INDESIT company

Model type:
BAN12X

Commercial code:
F044463

N1030093fig1

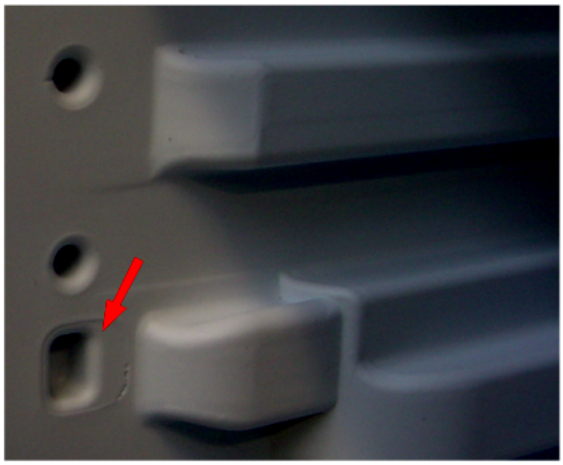
n1030093: New fixing of evaporator on static fridge-freezers (05 range) 60 cm,Melano

From August 05 (serial no. 50802.0001) the freezer evaporator is secured to the cabinet by a plastic profile.
The cabinet walls have been modified to create locations to house the profile, which is installed on the front of each evaporator plate (see photo N1030093fig1- fig2 - fig3)
The profile cannot be fitted on premodification appliances, so technical personnel must continue to fit the rh and lh supports on these models (see photo N1030093fig4)

New parts
C00141135 = WHITE PROFILE L=443.5 MM

Parts replaced
C00075596 = EVAPORATOR RH SUPPORT
C00075597 = EVAPORATOR LH SUPPORT
